AMENDMENTS TO THE DRAWINGS

HIGH VOLTAGE CABLE ASSEMBLY

Application No. 10/826,774

Reply to Final Office Action mailed 22 May 2006

Fig. 1

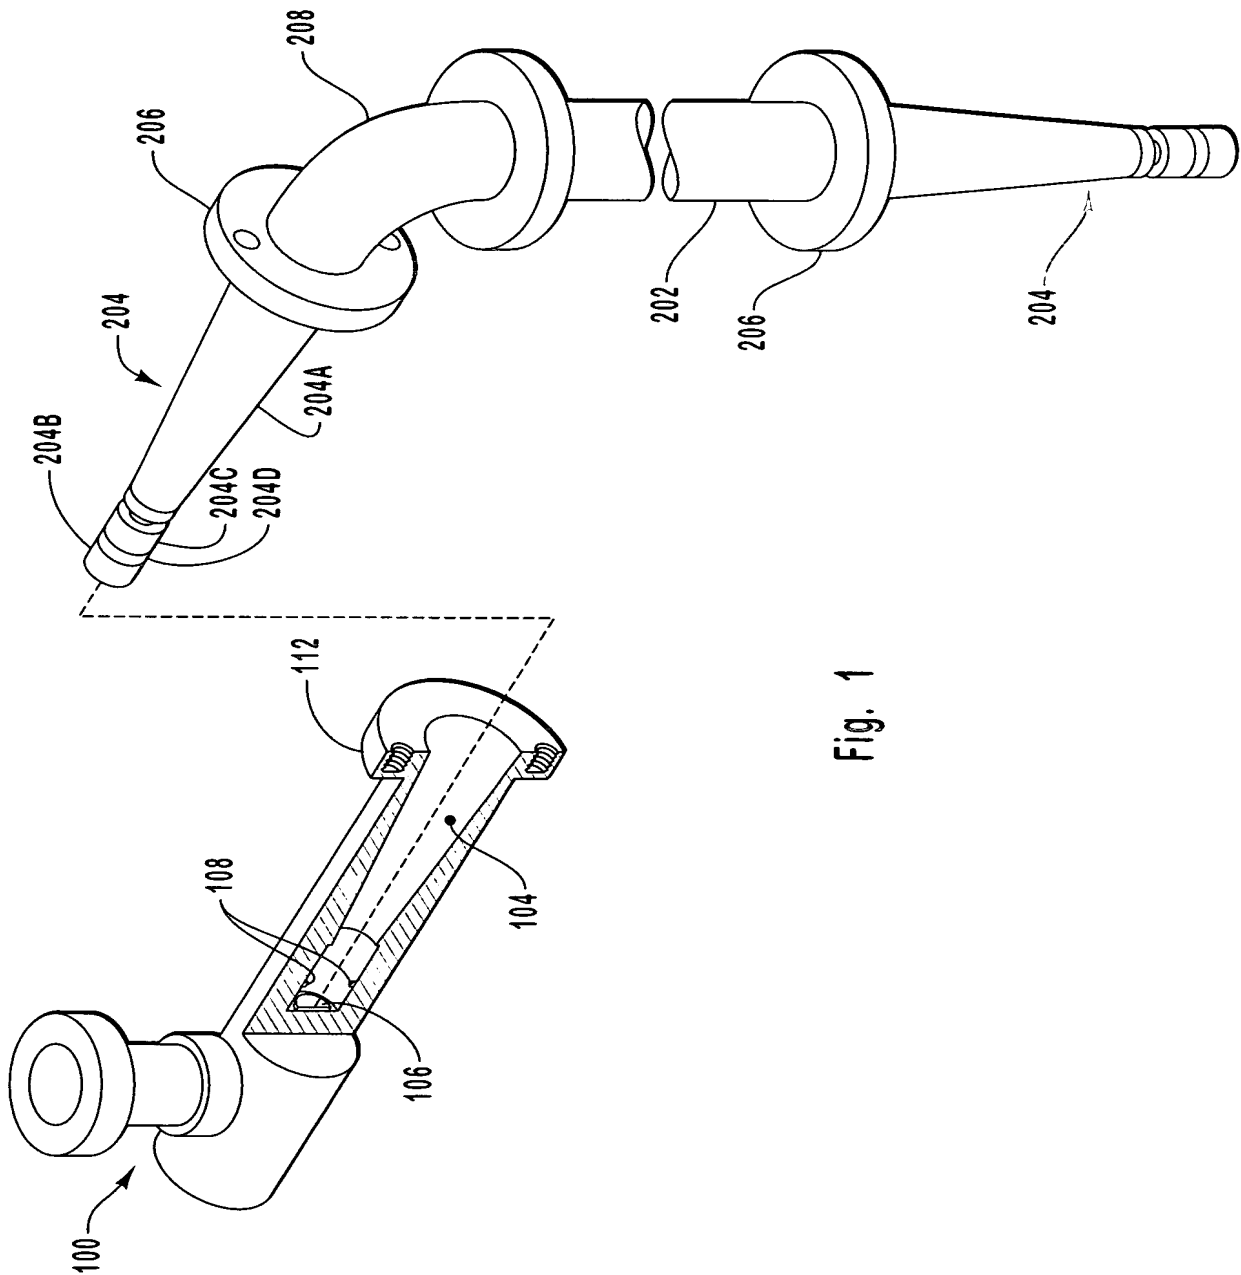
1. The Examiner has objected to Figure 1, apparently on the grounds that the "204" reference sign in the lower portion of the Figure does not include an arrowhead. In light of the Replacement Sheet 1 submitted herewith, Applicant submits that the objection has been overcome and should be withdrawn.

The attached sheets (3) of replacement drawings include changes to Figures 1, 2a and 3a. Replacement Sheet 1, which includes Figure 1, replaces the previous sheet 1 containing Figure 1. Replacement Sheet 2, which includes Figure 2a, replaces the previous sheet 2 containing Figure 2a. Replacement Sheet 4, which includes Figure 3a, replaces the previous sheet 4 containing Figure 3a.

Fig. 2A

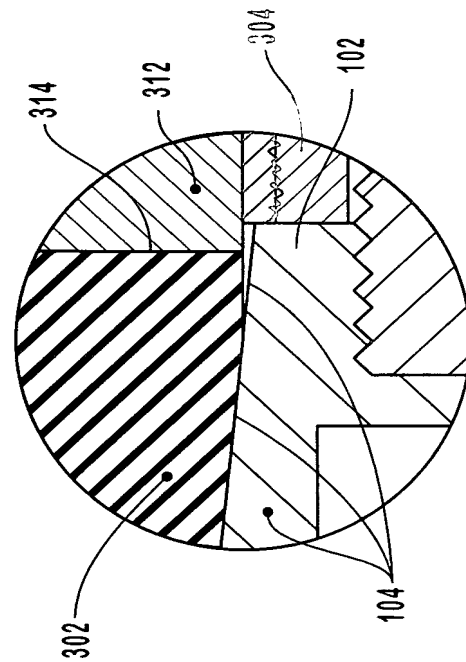
2. The Examiner has objected to Figures 2A and 3A, stating "there are two elements in rightmost portion shown with different hatching, one (numbered 312 in Figure 2A and one numbered 404 in Figure 3A) has hatch line different than those of another just below elements numbered 312 and 404. It is not clear what does the other element belongs to and why there is a gap between these two different elements."

In light of the Replacement Sheets 2 and 4 submitted herewith, Applicant submits that the objection has been overcome and should be withdrawn. With particular reference to Figures 2A and 3A, those figures have been amended to more closely conform with the specification. No new matter is believed to be entered as a result of the modifications to the figures.
